Groundwater Application Review Summary Form

Application # G- 19252

GW Reviewer Grayson Fish Date Review Completed: 12/8/2023

TO: Water Rights Section Date 12/8/2023
 FROM: Groundwater Section Grayson Fish
 Reviewer's Name
 SUBJECT: Application G- 19252 Supersedes review of _____
 Date of Review(s)

Water-Level Measurements in Nearby Wells

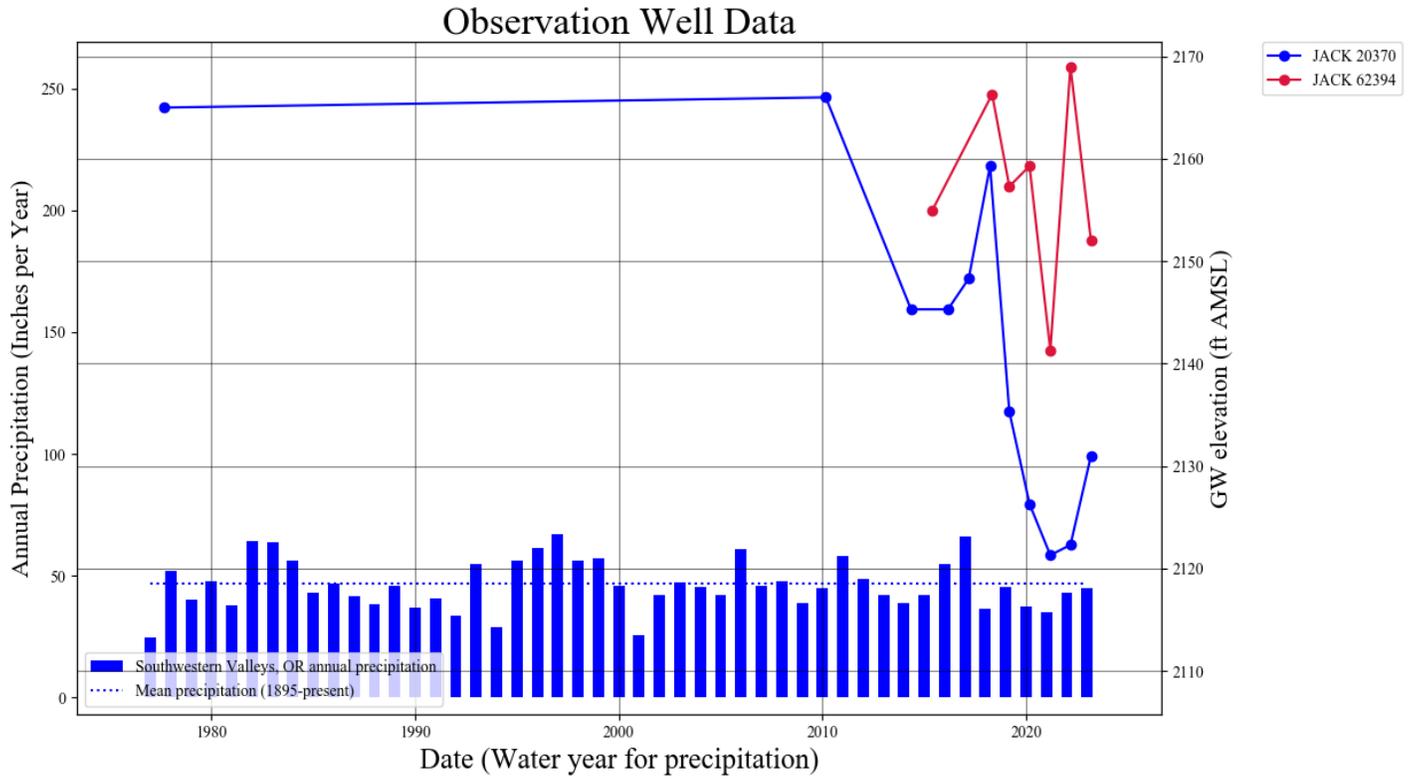
B3. **Groundwater availability remarks:** The applicant’s proposed well(s) will likely source water from an aquifer within fractures and jointing of the Payne Cliffs Formation (Wiley et. al., 2011). Median well yields for wells located in TRS 39S/1E-1, 39S/2E-6 and 39S/2E-7 are 27 gpm and a majority of reported static water levels are less 100 feet below land surface. Groundwater level data from the Payne Cliffs Formation in this portion of the Bear Creek Valley is limited. The closest observation wells are JACK 20370 and JACK 62394 located approximately 1.2 and 1.5 miles northwest of the proposed POA, respectively. Groundwater level data from JACK 20370 indicate that groundwater levels have declined 35 feet between 2010 and 2023. However, despite similar construction, JACK 62394 does not display similar declines. Given the distance between the observation wells from the proposed POA and the presence of several faults and creeks, it is unclear if the declines observed in JACK 20370 can be considered representative of groundwater conditions near the proposed POA. Regardless, the groundwater level trends in nearby wells do not meet the definition of excessively declined or excessively declining per OAR 690-008-001 (4) and (6). Groundwater does not appear to be over-appropriated.
